RE: Notice of Violation #10072, Abatement Action – Suspended Solids  
Dugout Canyon Mine, Canyon Fuel Company, LLC, C/007/039, Carbon County, Utah

# APPLICATION FOR COAL PERMIT PROCESSING

**Title:** Notice of Violation #10072, Abatement Action

**MP Monitoring and Treatment Plan**

MP Monitoring Location

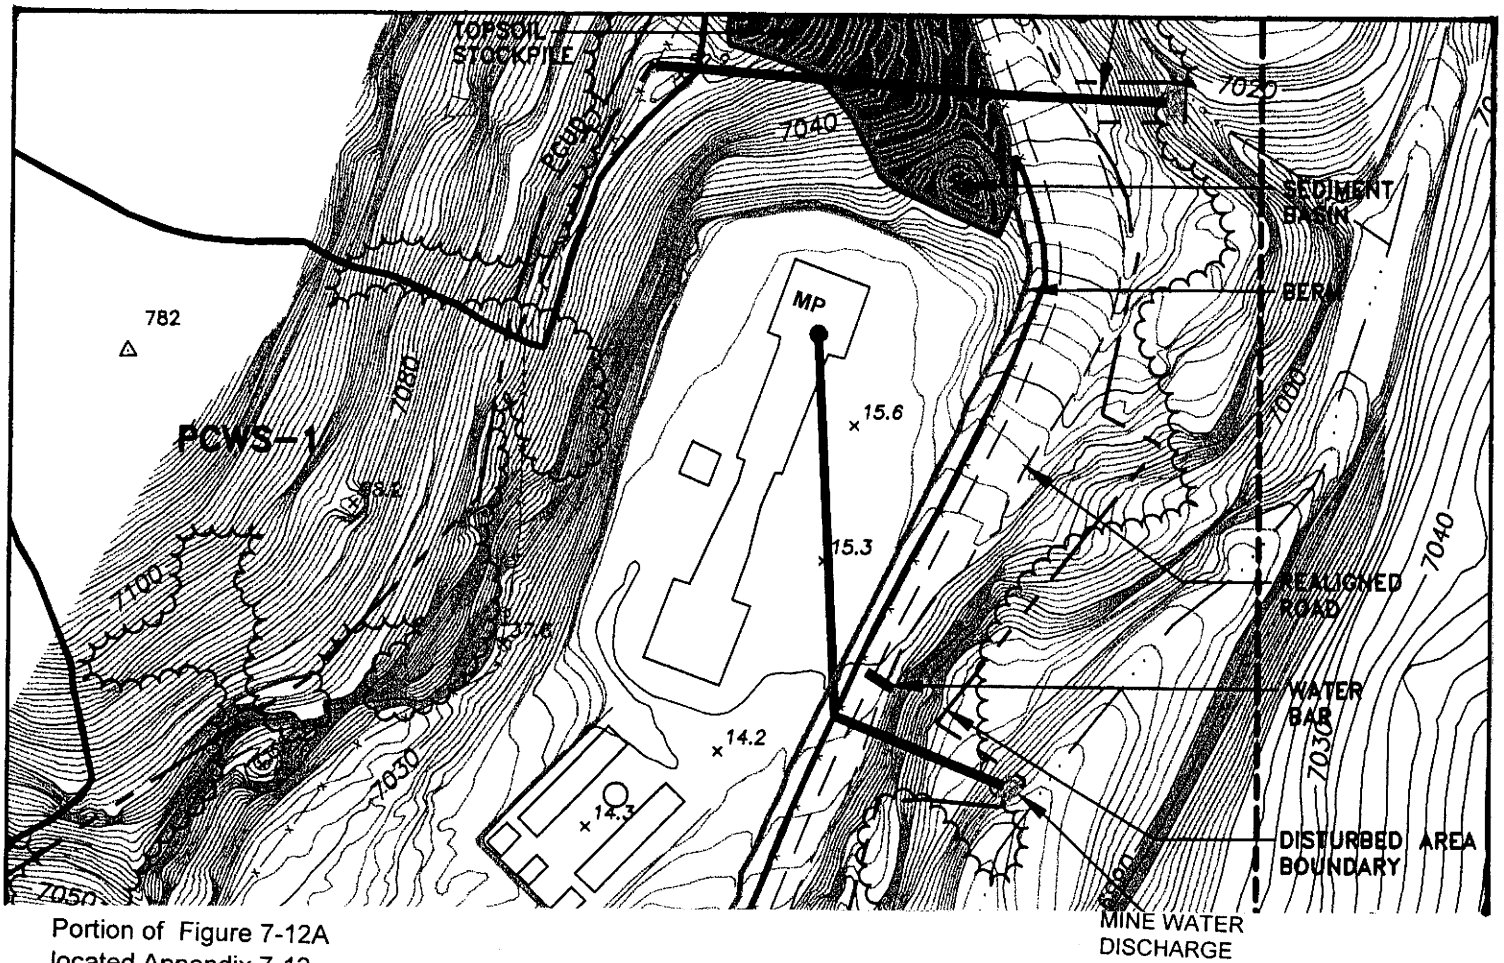
Monitoring point located on 8" pipe at Pace Canyon Fan Portal, refer to attached drawing and Plate 7-1 for the location. The monitoring point is on a pipeline at the fan portal which contributes a portion of the water discharged at Outfall 005.

The MP location can be used for monitoring/sampling pre-treatment water in an 8" pipeline at the Pace Canyon Fan Portal. This pipeline only contributes a portion of the water being discharged to Outfall 005.
